# **Ottawa LRT Independent Review Report**

April, 2022  
Confidential

City of Ottawa  
c/o Singleton Urquhart  
Reynolds Vogel LLP  
150 King St West, Suite  
2512  
Toronto, ON  
M5G 1J9

**Figure 3.8: Corrugation on Low Rail of Curve 210 at 104+725**

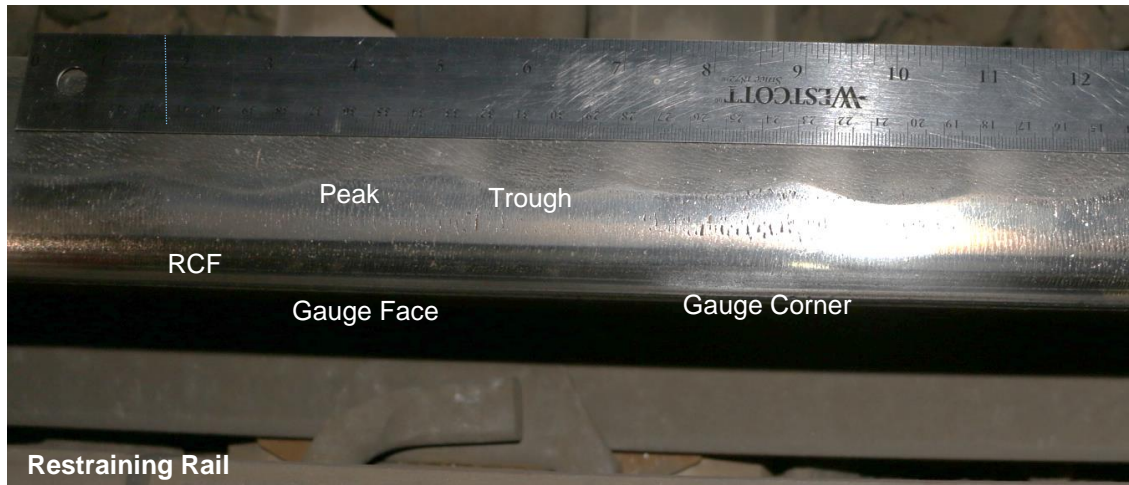
Corrugation on the low rail is located near the crown of the rail, **Figure 3.8**, **Figure 3.9** and **Figure 3.11**. There is also wheel contact on the gauge corner and the gauge face shown by the shiny polished surface. In contrast, corrugation on the high rails extends from the crown of the rail through the gauge and down the gauge face in the form of periodic side wear **Figure 3.10** and **Figure 3.12**. **Figure 3.12**: Corrugation on High Rail of Curve 330 at 108+685 Figure 3.12: Corrugation on High Rail of Curve 330 at 108+685 shows two types of corrugation on the high rail, a long wavelength at the gauge corner with a shorter wavelength on the crown. There is evidence of plastic deformation occurring in the trough of the corrugation with plastic flow of the rail surface towards the field side away from the gauge corner, **Figure 3.9**. There is also some evidence of material breaking away “spalling” from the surface of the trough, **Figure 3.11**.

RCF in the form of head checks is present on the low rail on some curves, **Figure 3.8**, and **Figure 3.9**. No RCF is present on the high rail on the photographs examined.

**Figure 3.14: Wheel Burns and Periodic Patches on Rail at Blair Terminus**

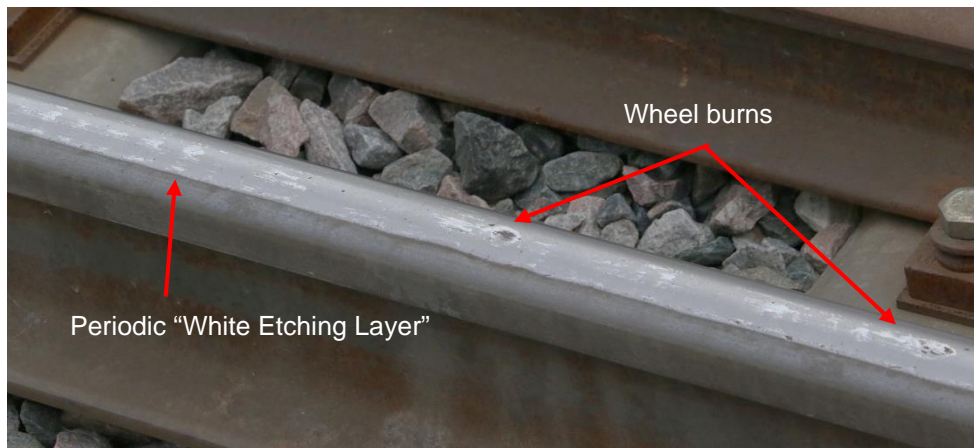
There is evidence of engine or wheel burns on the head of the rail at one location, **Figure 3.14**; these occur due to wheel slipping on the rail locally heating the surface transforming the steel to a brittle phase. These can result in cracks initiating which can propagate down into the rail leading to failure if they are not managed. At the same locations are periodic shiny patches on the surface of the rail that seem to occur at similar wavelengths to the corrugation. This is likely to be white etching layer which is often formed on the surface of rail by the transformation of the surface due to a combination of plastic deformation and heating (but not sufficient to cause wheel burns)<sup>2</sup>. WEL are often present on corrugated rail but its role in the formation, if any, is unclear<sup>3</sup>.

**Figure 3.17: Rolling Contact Fatigue on Low Rail of Curve 210 at 104+725**

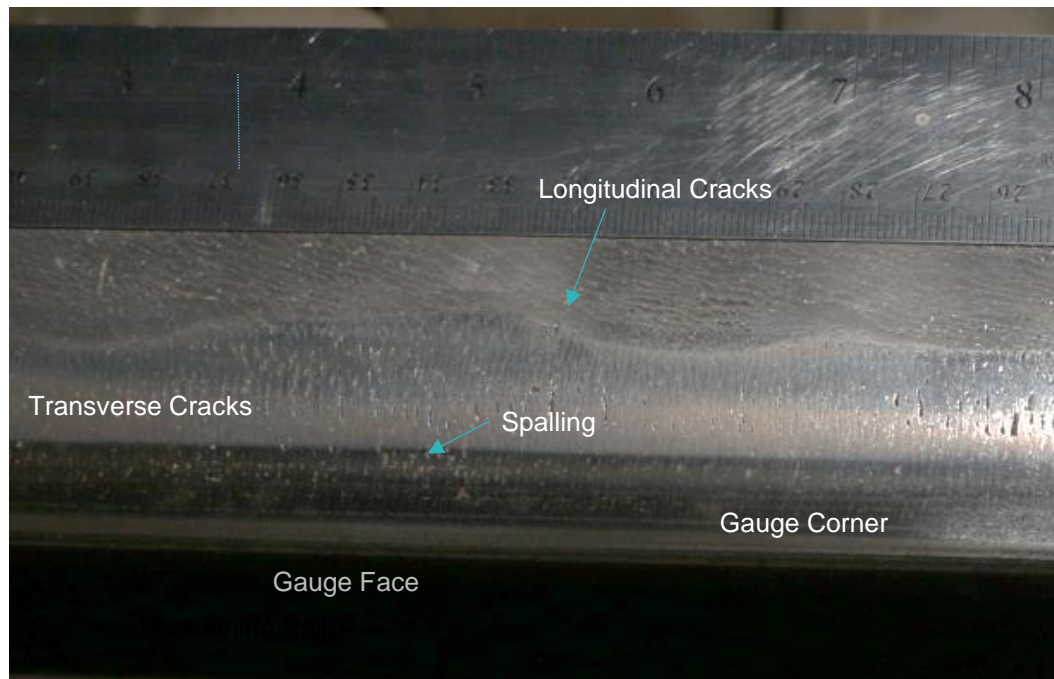
Observations of the photos from the site visit by Mott MacDonald has shown that RCF cracks are present on the surface of the low rail, **Figure 3.17** and **Figure 3.18**. There appears to be two forms of cracks on the rail, transverse cracks near to the gauge corner which are closely spaced and in places have joined up with material “spalling” from the surface. There are also secondary longitudinal cracks nearer to the crown associated with the location where the corrugation is present. The two forms of cracks and the running bands indicate that wheels are contacting the rail in two different places. One near the gauge corner where the contact forces are predominantly along the length of the rail and the second contact near the centre of the rail head where the forces apply transversely to the rail.

A review of the wheel/rail videos has shown that on the curves where corrugation is present the leading axle of the motor truck is offset to the outer side of the curve with the wheel flange in contact with the high rail gauge corner. Although not visible, the trailing axle on the truck is likely to be offset the other way with the flange in contact with the low rail gauge corner. The running bands and the different RCF cracks on the low rail provide evidence for this, **Figure 3.17**. With the leading axle offset to the high rail, the low wheel contacts the crown of the low rail where the corrugation is located, the forces appear to be towards the field side shown by the longitudinal cracks and evidence of plastic flow in the corrugation troughs. The contact on the high rail is at the gauge corner with high contact forces resulting in corrugation and side wear, **Figure 3.10**, and **Figure 3.25**. The trailing wheel set is offset to the inside of the curve resulting in flange contact on the low rail resulting in no corrugation on the gauge corner but transverse RCF cracks forming, **Figure 3.17**, and small levels of side wear, **Figure 3.25**.

**Figure 3.27: As-built v Design Contact Wire Height – Eastbound Track**

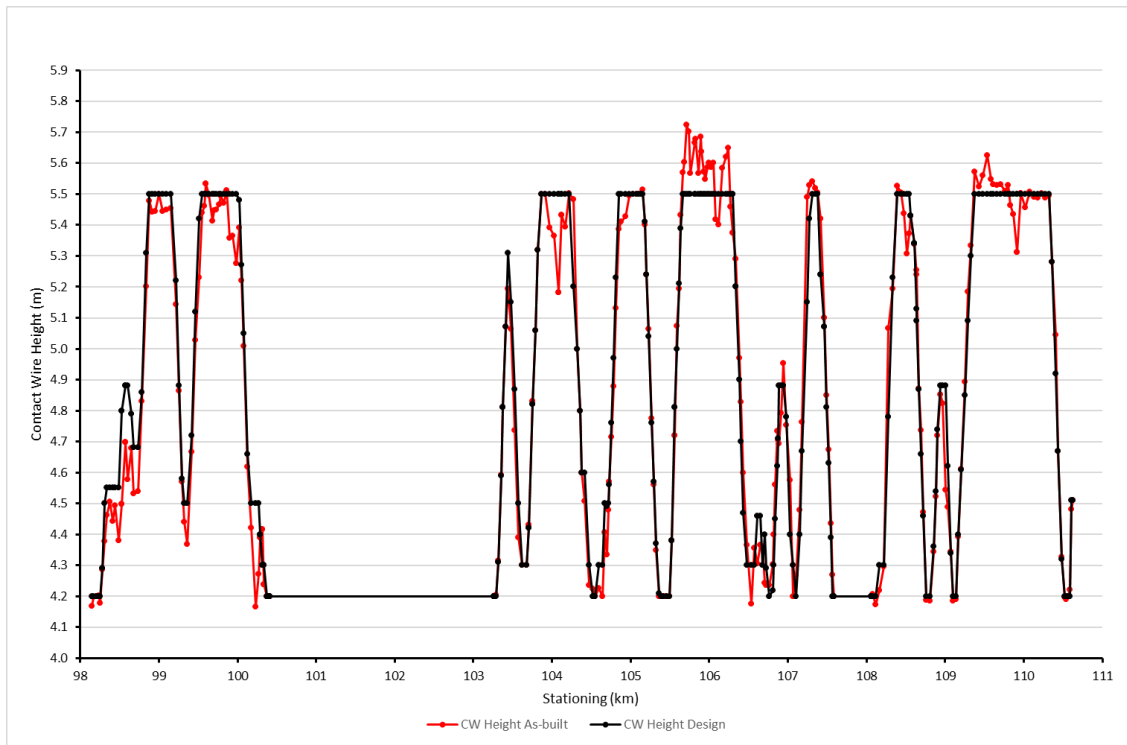
Contact wire heights were reviewed in both the eastbound and westbound directions. **Figure 3.27** is provided to show graphically the eastbound contact wire heights (and is a reasonable proxy for the similar westbound representation). The as-built profiles (in red) are typical to those presented in the Alstom report.

**Figure 3.29: As-Built v Design Contact Wire Stagger – Eastbound Track**

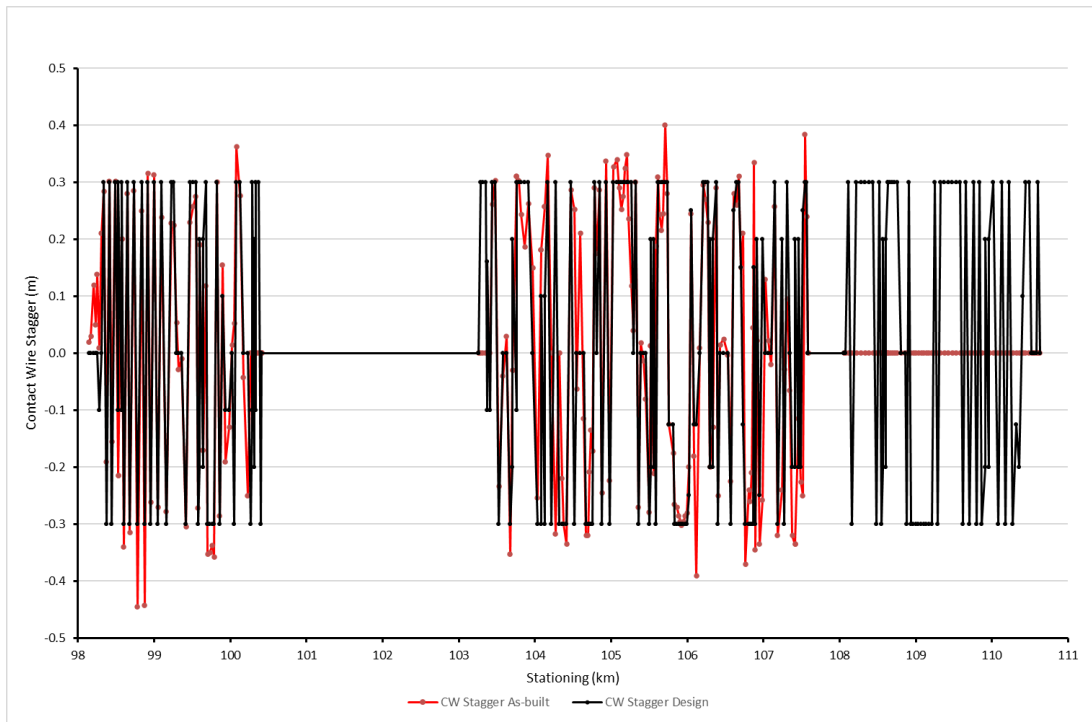
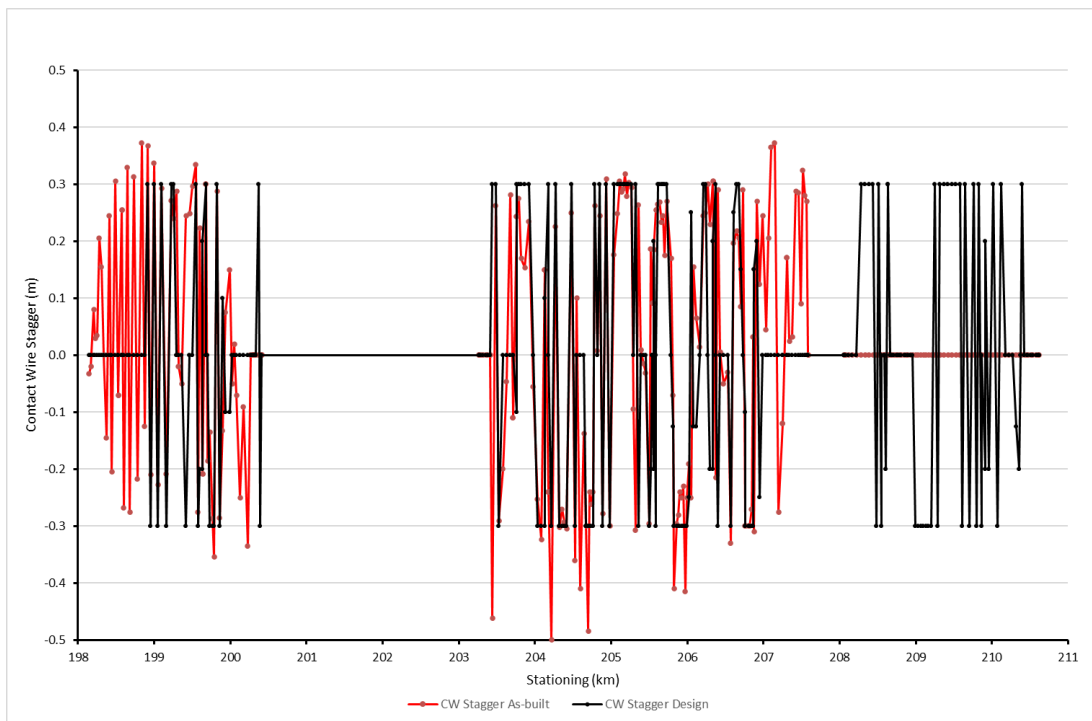
Based on the maximum allowable design gradient for the main line of 0.8%, it can be seen in **Figure 3.29** and **Figure 3.30** that there are areas where the design and as-built contact wire grading does not meet the requirements of the Project Agreement Schedule 15-2 Part 4, Article 8. The implications of excessive grading can be either a reduction or increase in the contact force on the pantograph, which can lead to:

The as-built contact wire stagger for both the eastbound and westbound tracks were compared with the design and are shown graphically in **Figure 3.29** and **Figure 3.30**.

Based on PA Schedule 15-2 Part 4 Article 8, there are a number of locations that do not meet the installation tolerance of -25 mm to + 25 mm. This has resulted in the staggers being either smaller or greater than the design and could affect the contact wire/pantograph interface. Note the as-built and design values for the tunnel sections were not available at the time of the analysis and has not subsequently been provided.

**TableFigure 3.36: RailPod Data Analysis of SW313 Crossover Wire Heights**

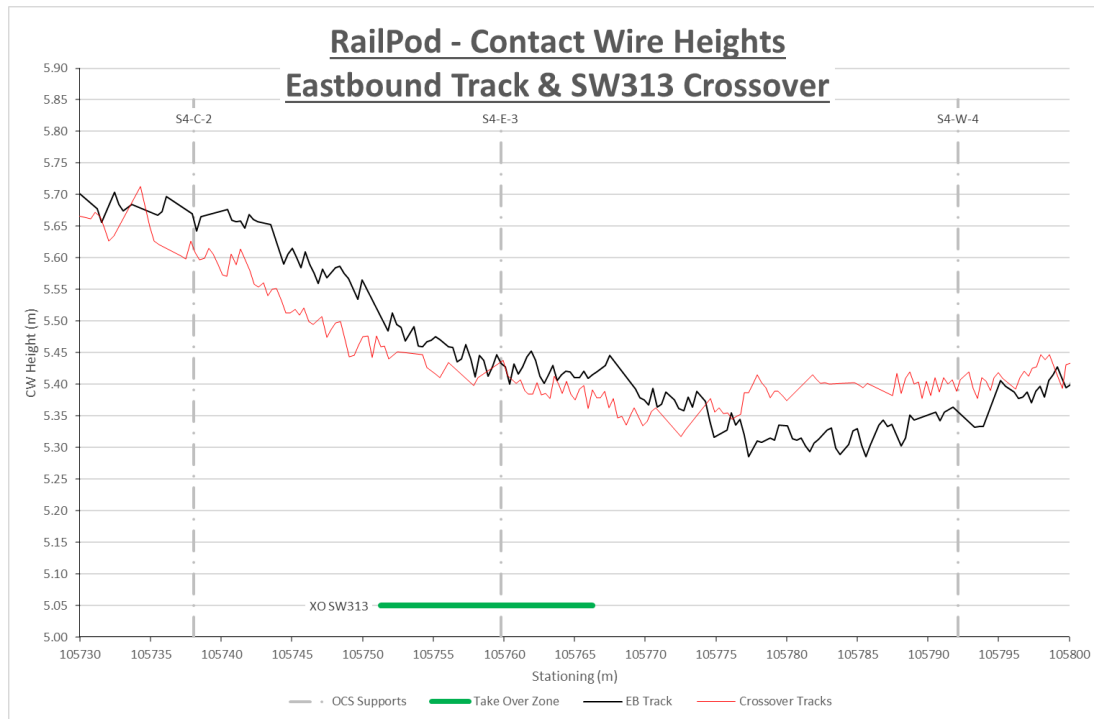
A typical example of where this is occurring is at crossover SW313 on the eastbound track. On the video, reference Gx060037-6 – at 16 seconds in, a sound can be heard as the pantograph hits the crossover wire. From the RailPod survey the observation can be confirmed as the crossover wire, within the take-over zone is lower than that of the main as shown in Figure 3.36.

**Figure 3.45: Overview of Emergency Brake Events (Overspeed in ATO and Crawlback) Per Month**

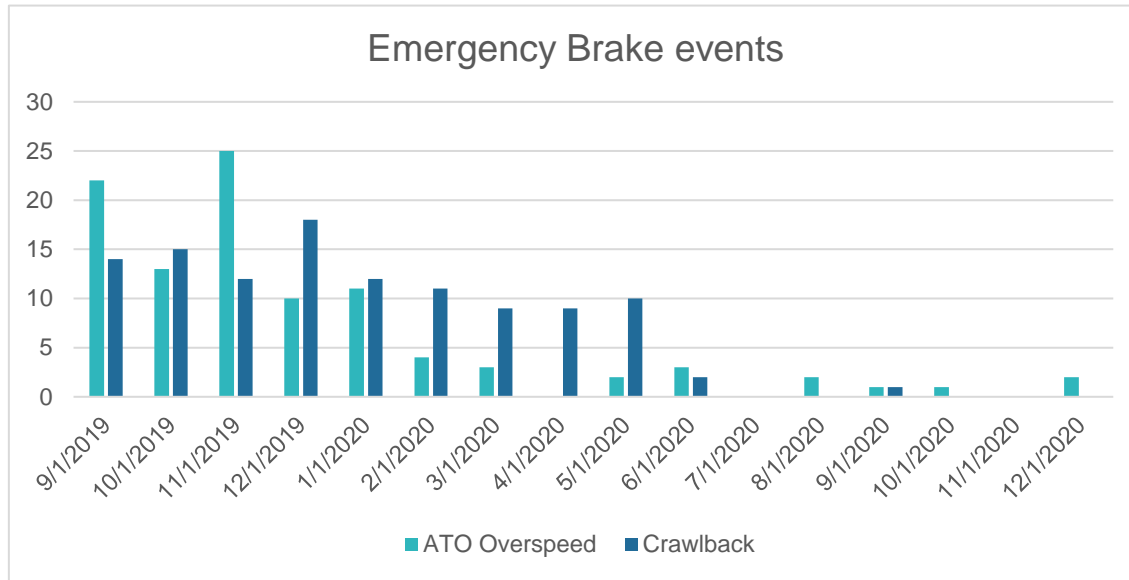
As visible in **Figure 3.45**, from June 2020 onwards, the number of EB due to unauthorized crawlback events has decreased significantly which could be following the upgrade of the Thales CBTC software.

**Figure 4.5: MSF1 Access Issue to LMB 1 and 2 from East Side of Facility**

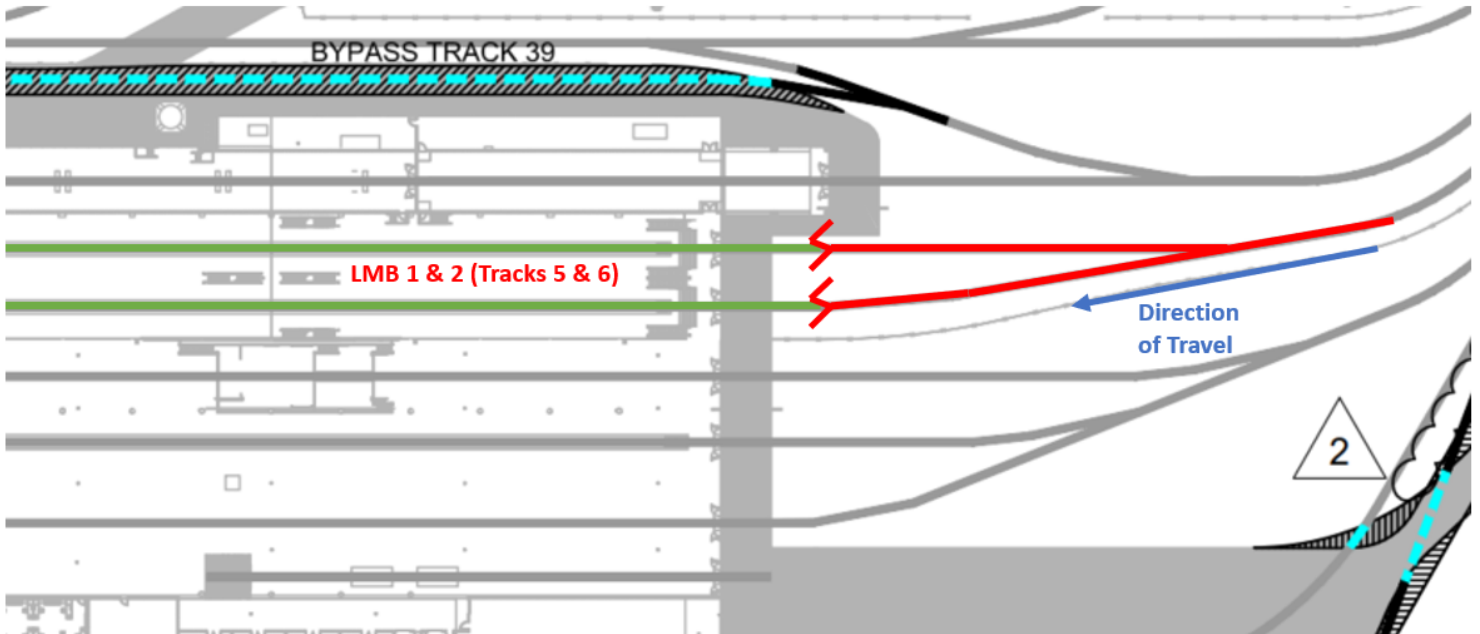
The Mott MacDonald team was also informed that when vehicles try to enter LMBs 1 and 2 from the east side of MSF 1, the main fuse associated to LMBs 1 or 2 is blown and overhead power turns off. The maintenance team has adapted to this issue by not running vehicles from the east side of the yard into LMBs 1 and 2. This issue adds to the movement challenges presented by the design of the yard: vehicles in the storage shed or at MSF 2 that need to be moved to LMBs 1 or 2, have to be moved to the mainline connector track and entered into MSF 1 through the west side of the facility (**Figure 4.5**). It is possible that

A review of OCS and Trackwork drawings has shown that there are some minor discrepancies between the two packages, but nothing has been found which would be an obvious cause for the issue. According to the Rectification Plan, the proposed solution was to be implemented by early 2021. However, Mott MacDonald was informed by Project Co that this was an ongoing issue at the time of the site visits. Project Co need to provide evidence that the proposed rectification has taken place and the issue has been resolved, or a revised plan showing when the proposed solution will be implemented.

**Figure 4.8: Other Potential Vehicle Launch Tracks**

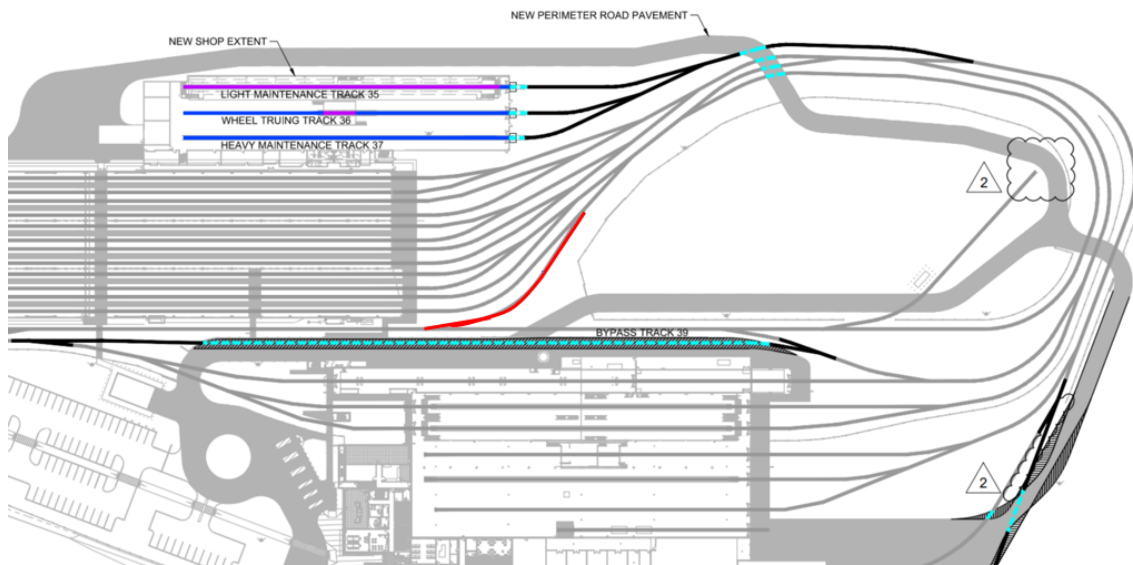
Other tracks could be used for launching vehicles for revenue service including bypass track 39 and track 22 (**Figure 4.8**). The Mott MacDonald team was informed that bypass track 39 is not used and has not been commissioned as it is part of the project's Stage 2. This constraint adds further to the limited operational efficiency and flexibility of the MSF track layout.

**Figure 5.11: Track Geometry as Reported in Alstom Incident Report TN-024**

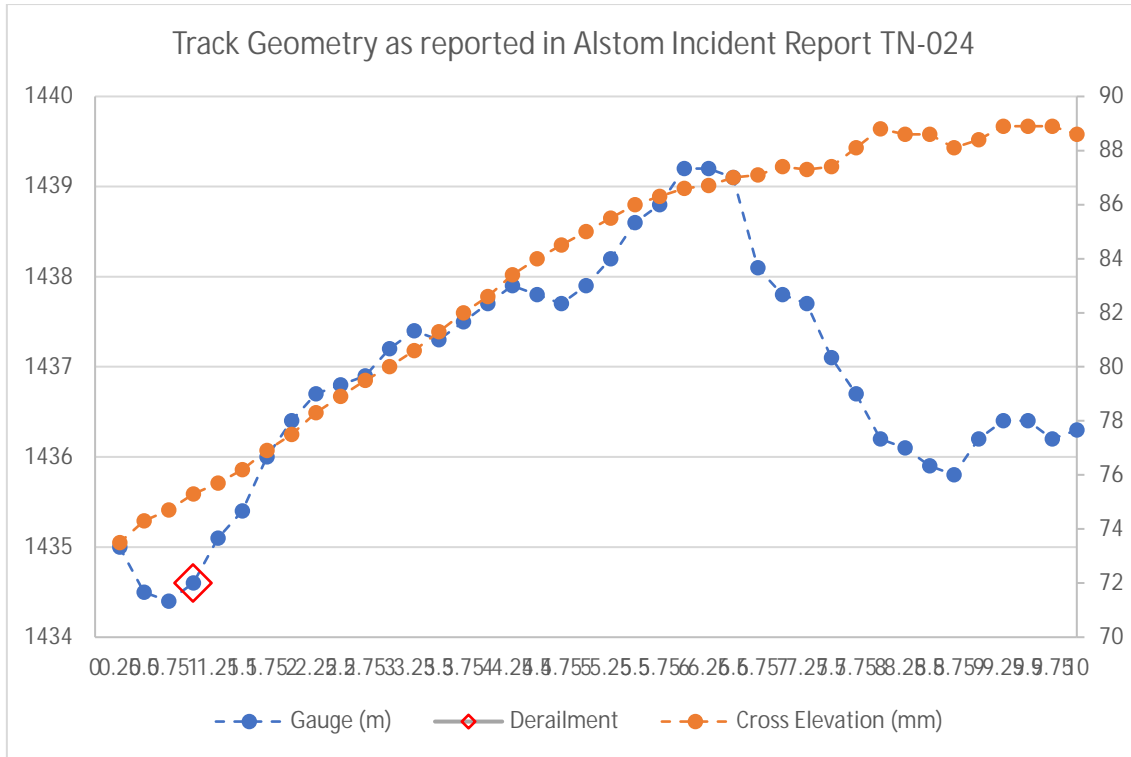
The Alstom incident report contained 10m of gauge measurements which include the suspected location of the derailment. If the connector tunnel is considered part of the yard, all of these gauge measurements are within the reported tolerances. It is worth noting that the location identified for the rail climb and therefore derailment location is just after the tightest gauge location. There is also a note in Alstom's incident report TN-018 for LRV1126's yard derailment that "per best practices of fail, it is recommended to have gauge widening in sharp curves." The connector tunnel's tightest curve radius is 55.15m.
